RE: 375200 – Joint Forces Headquarters
Response to Comments

The purpose of this letter is to respond to questions dated November 29, 2013 regarding the conditional use and major development application for the proposed Joint Forces Headquarters project in Augusta. Our responses are in bold italics following a re-statement of the questions.

SITE OVERALL LAYOUT PLAN

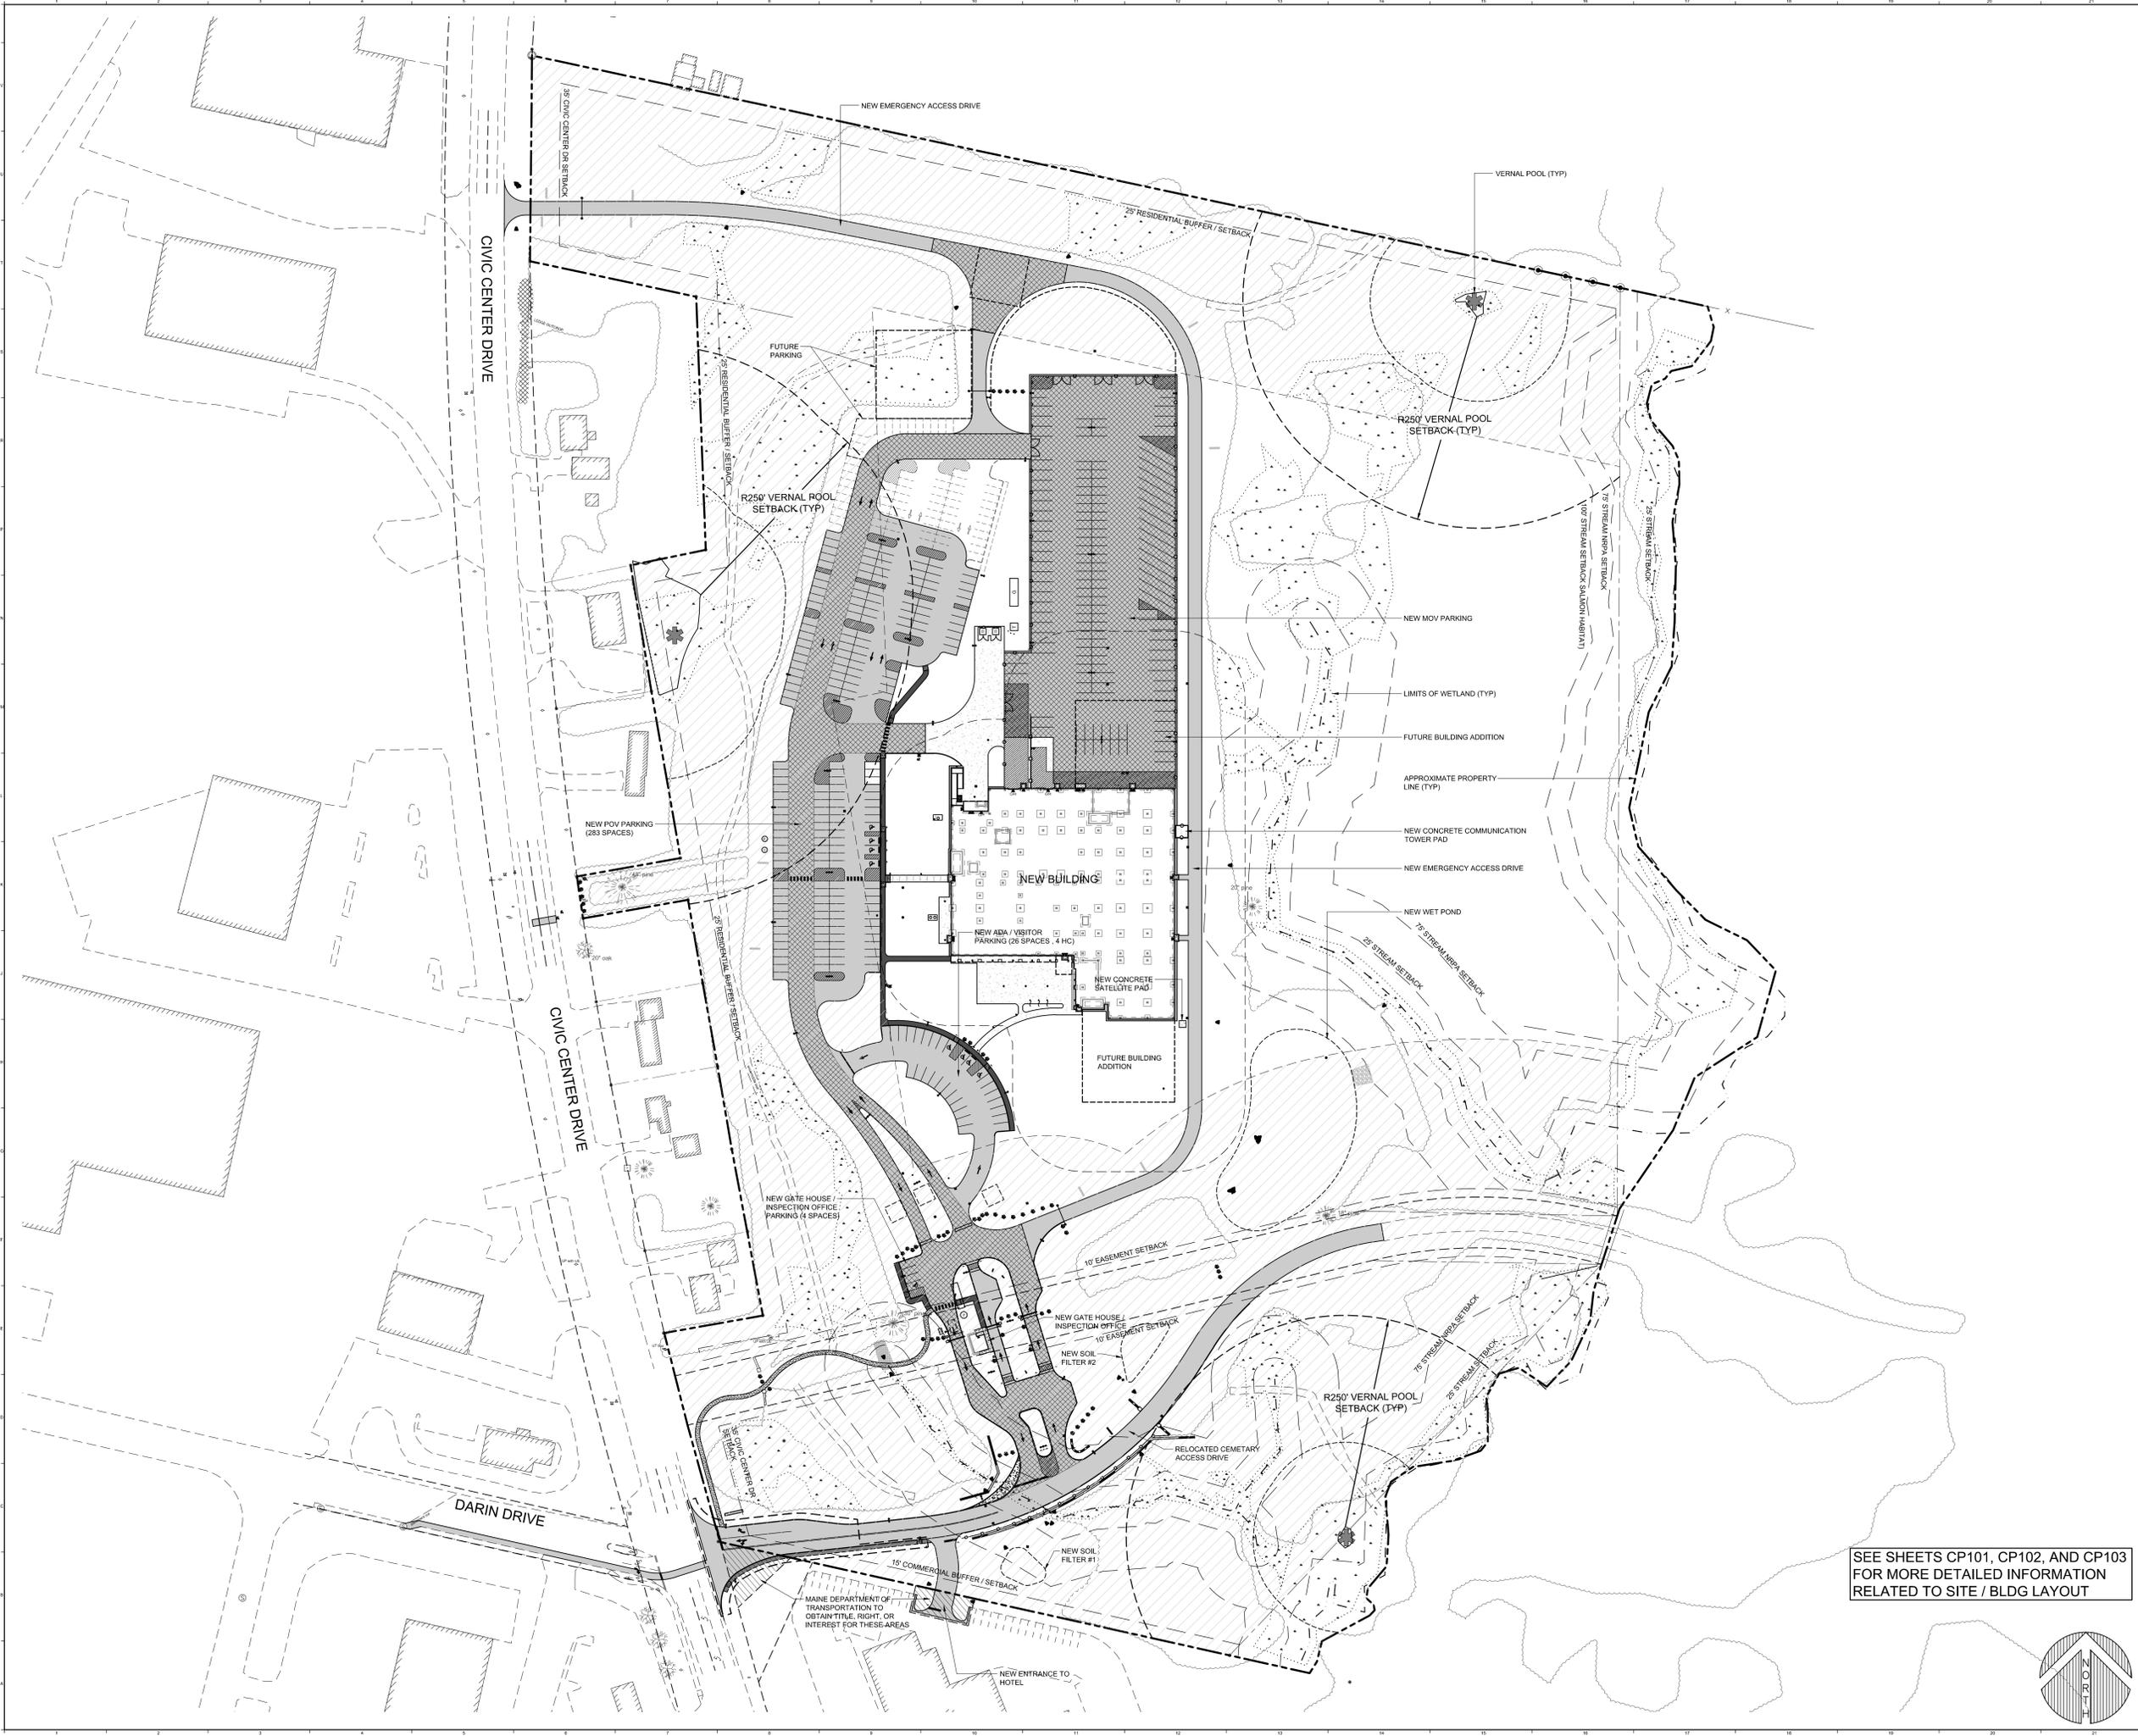
1. Title/right/interest. No title/right/interest has been submitted for the realignment of Blue Star Avenue across from Darin Drive. Demonstration of title/right/interest is required for all portions of the project in order for the application to be complete. The Planning Board cannot do the conditional use and major development application review until the applicant has demonstrated title/right/interest for the entire project. What is the status on the Maine Army National Guard receiving title/right/interest to the portion of the realigned access drive that is closest to Civic Center Drive? ***The quitclaim deed for the project parcel is included in the application package. The Maine Department of Transportation (MDOT) is planning to improve the existing unsignalized intersection at Civic Center Drive and Darin Drive. These improvements include the acquisition of title right or interest for a 3050 SF and a 2315 SF portion of the parcel located to the south of the project parcel. My understanding is that the MDOT is in the process of obtaining title right or interest for these areas and that they anticipate that negotiations will be concluded in the near future. Brian Keezer PE, multimodal project manager at MDOT, is coordinating this project (624-3612). Intersection construction is scheduled for 2015. Note that the utility easement on Darin Drive is not needed. See revised sheet CP100 – Site Overall Layout Plan and sheet CP102 – Site Layout & Materials Plan.***
